**ADDENDUM
(AD)**

PROJECT: **Concrete Industries**
Break Room and Locker Room Improvements
Lincoln, Nebraska

AD NO.: 2

DATE: December 12, 2024

A-201

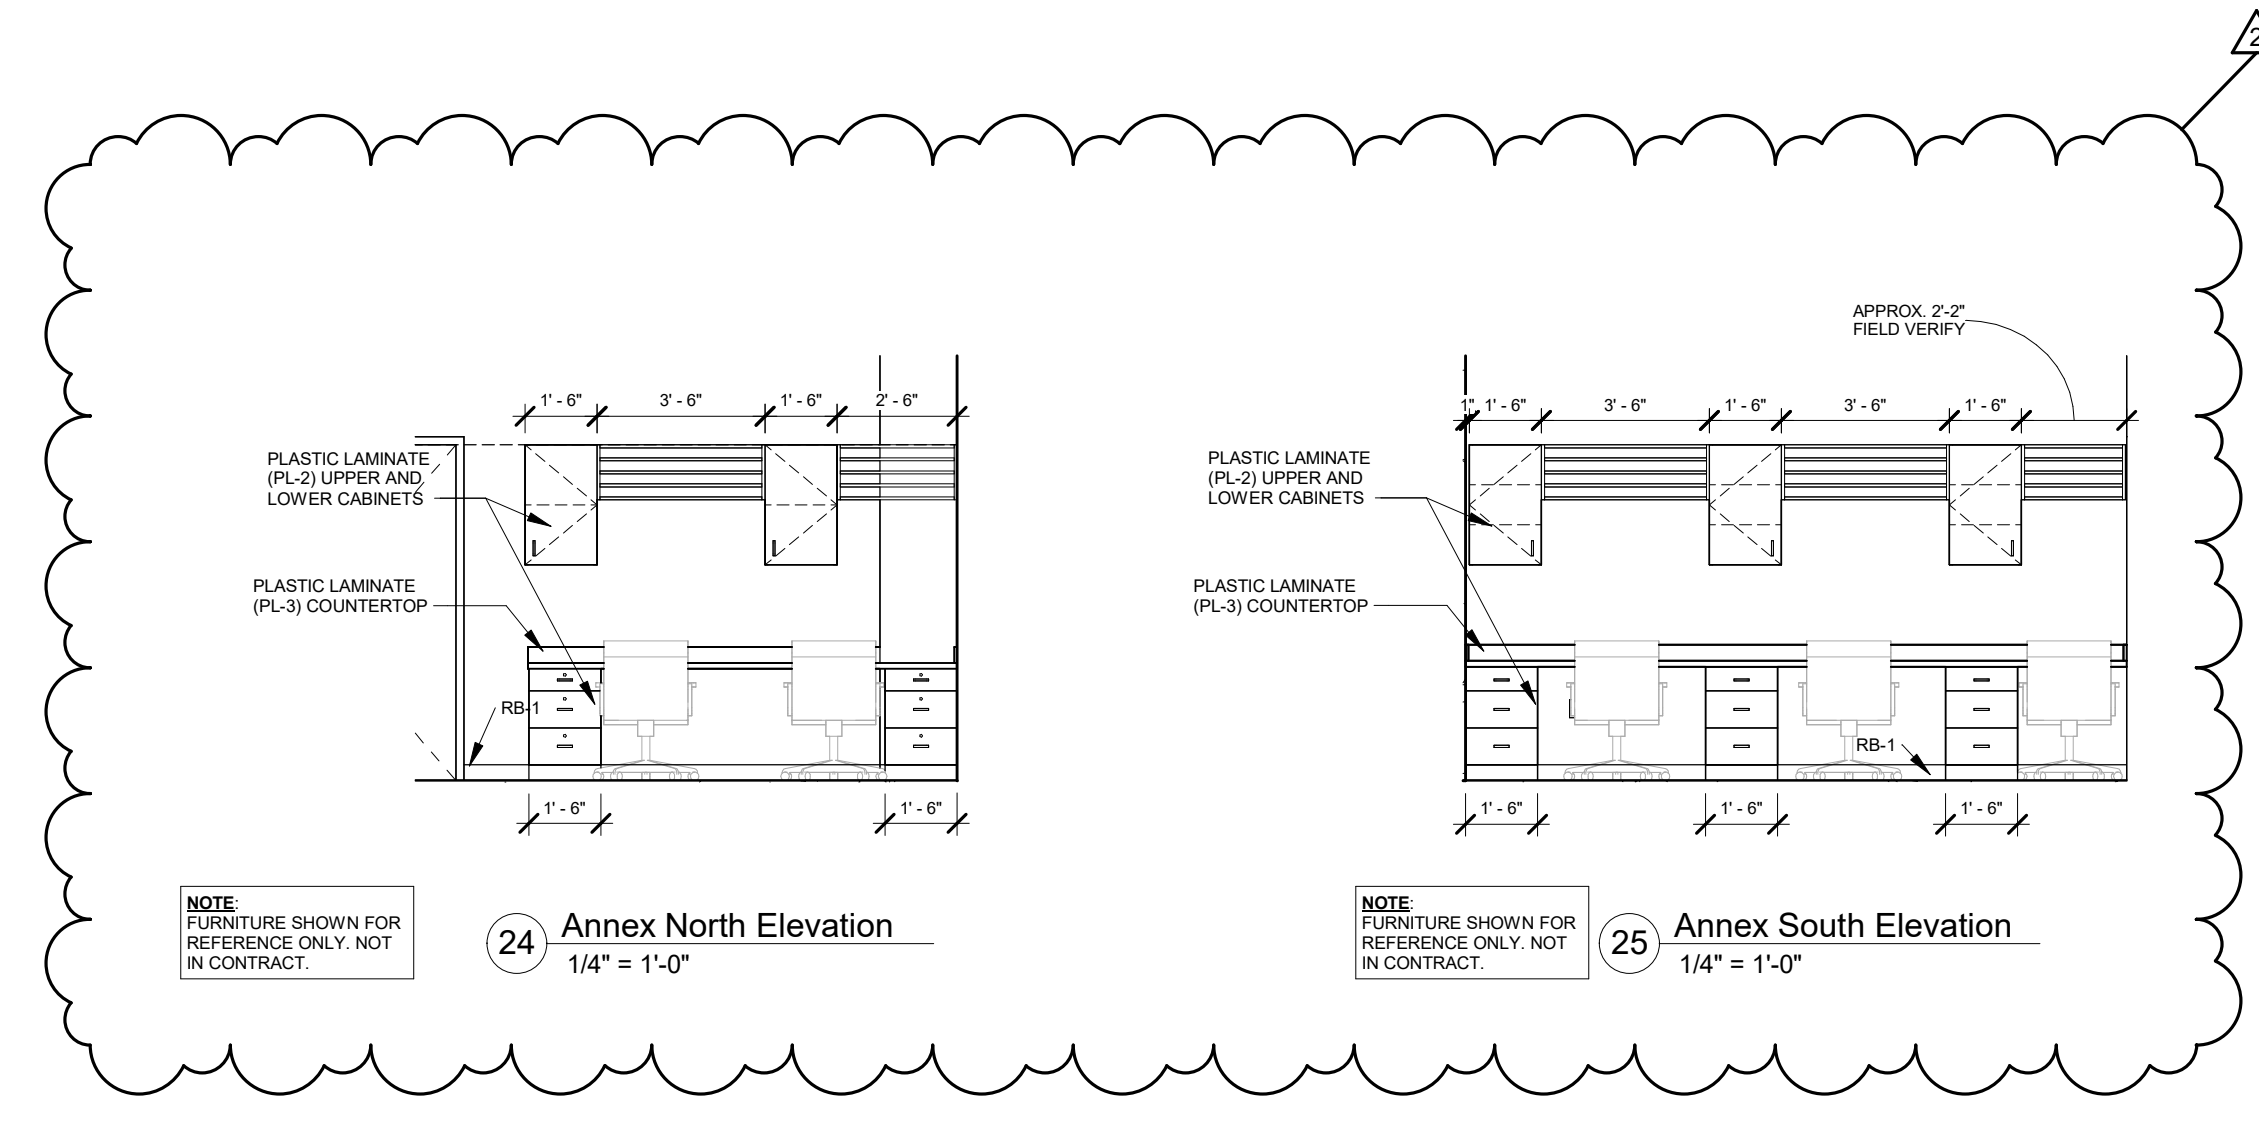
In reference to Sheet A-201, see attached revised sheet removing redundant elevations and incorrect material call outs. Two elevations have been added to show casework for Lead Man's Annex 115.

SHEET NUMBER
I-101

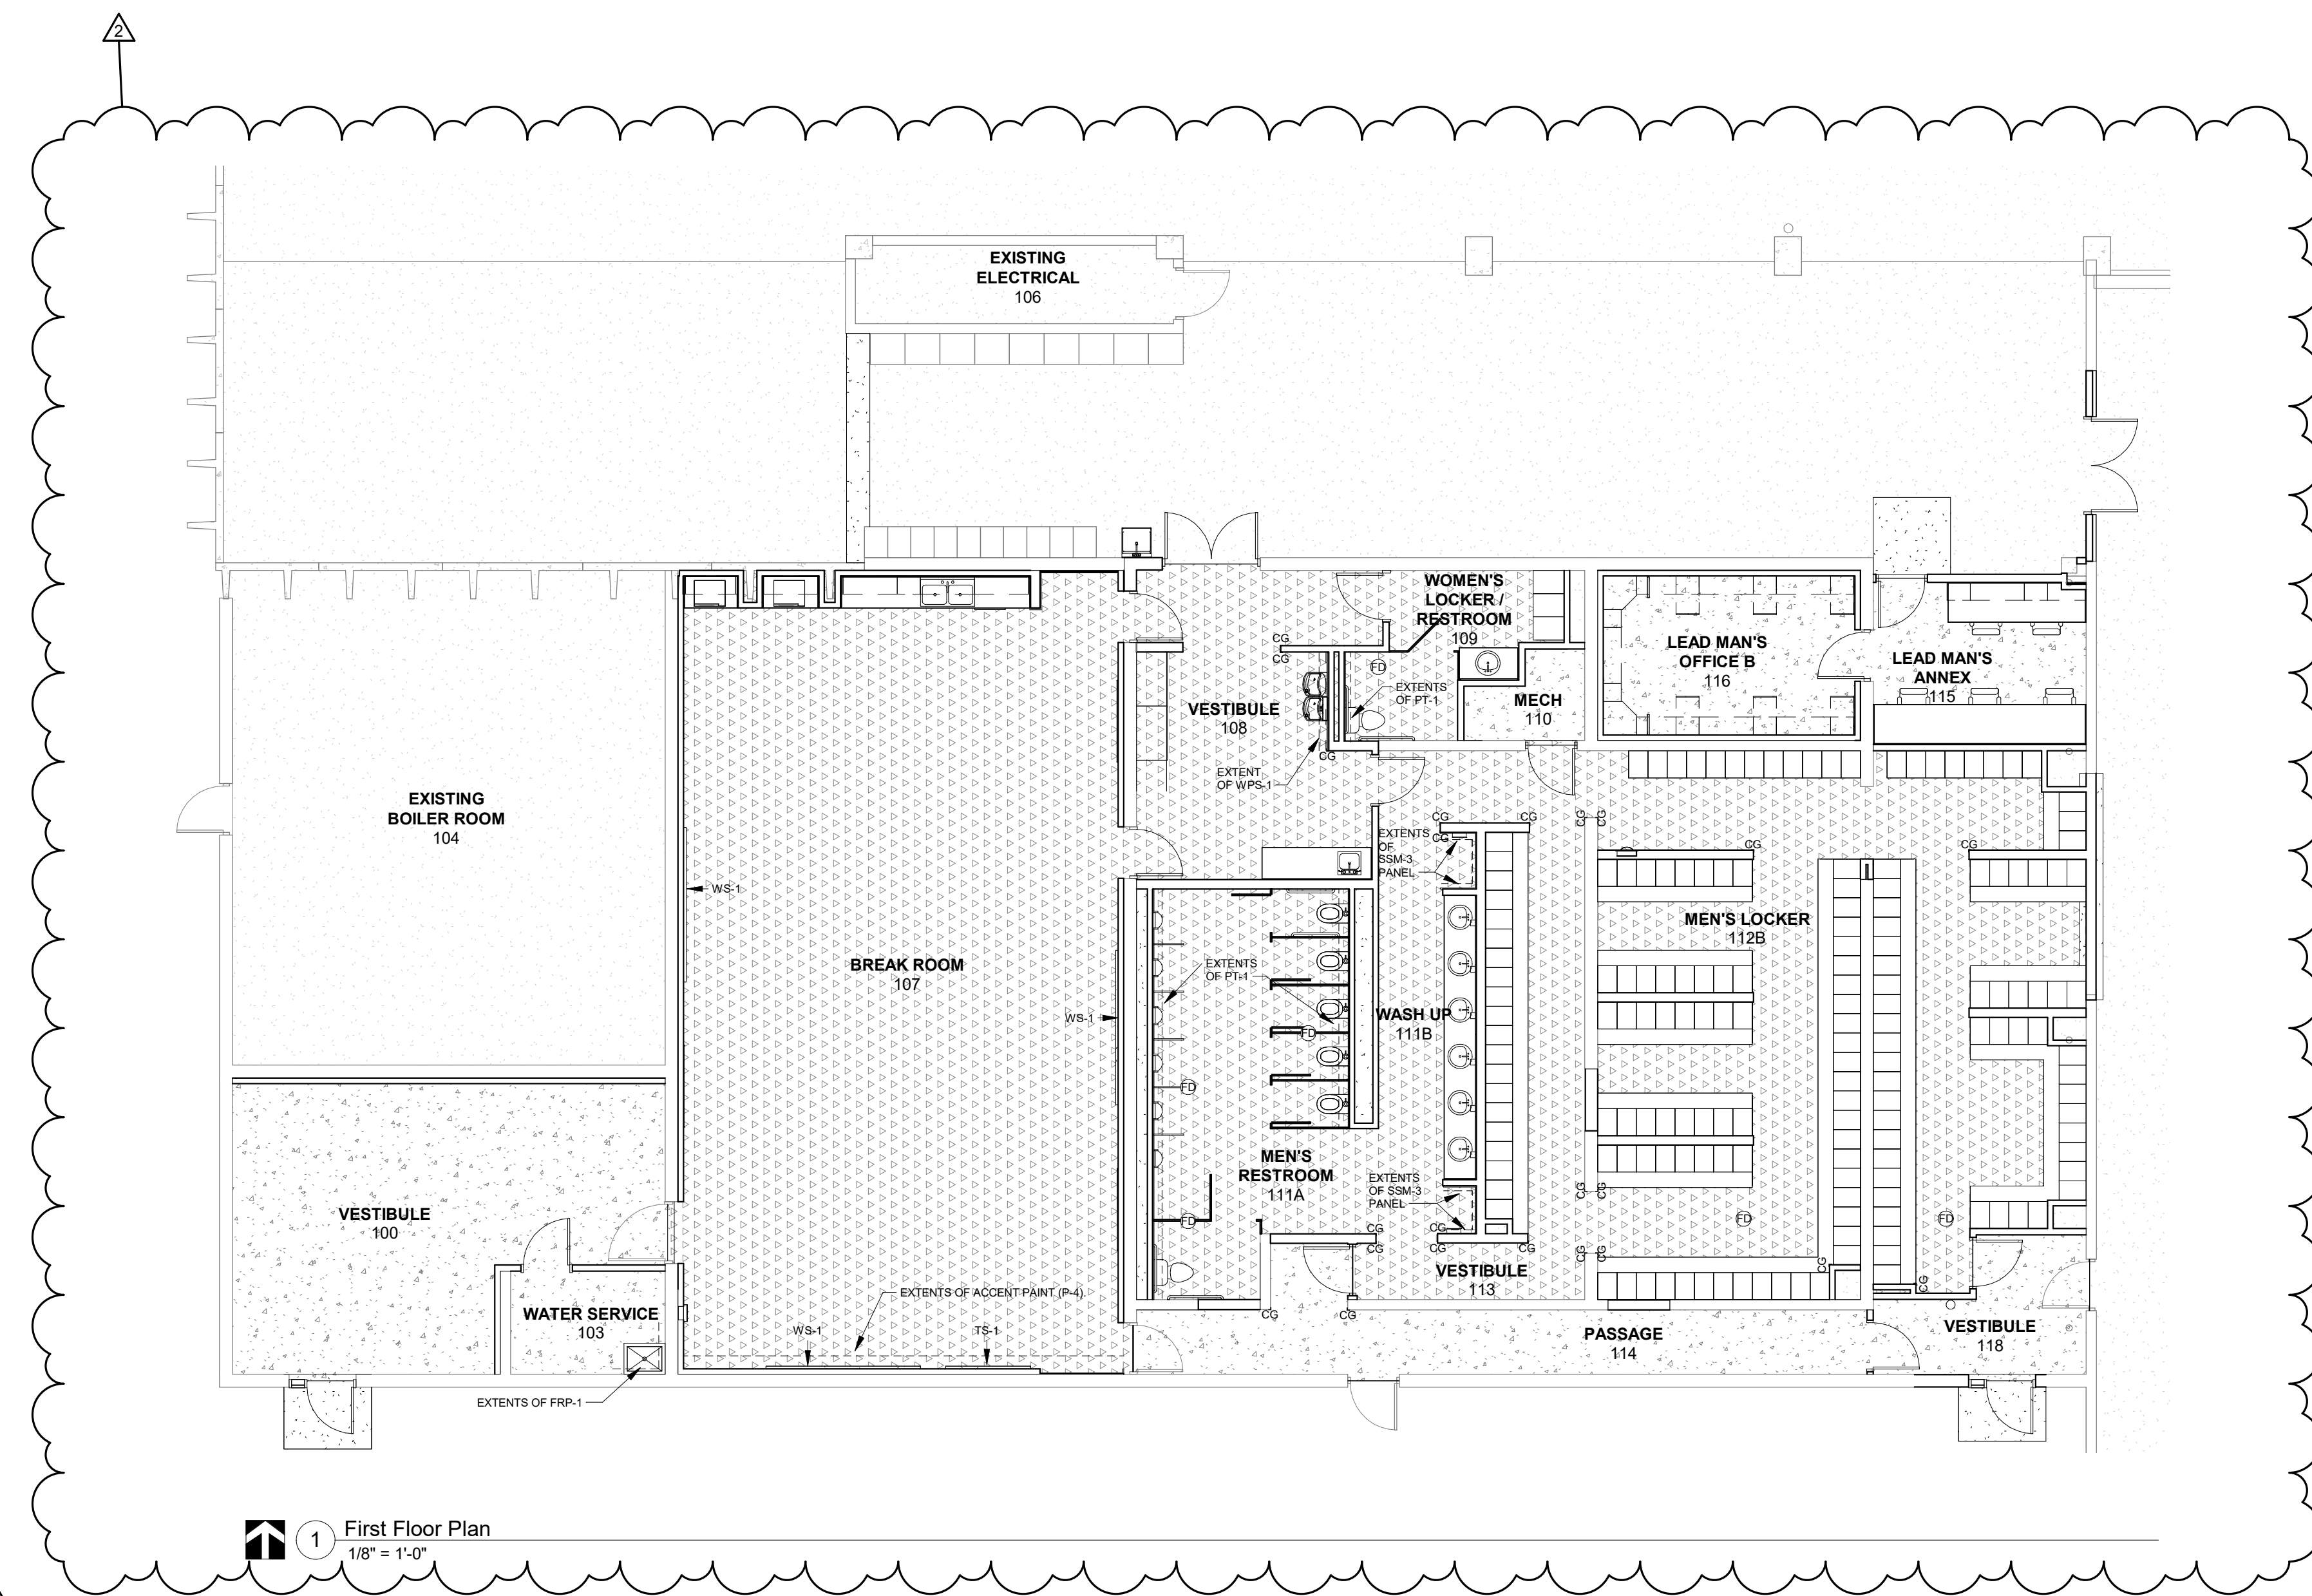
In reference to Section 096723 – Resinous Flooring, entire section is attached to be added to the specification book. See attached I-101 sheet for extents of resinous flooring finish.

In reference to Sheet I-101 – Floor Finish Plan & Room Finish Schedule, see attached revised sheet.
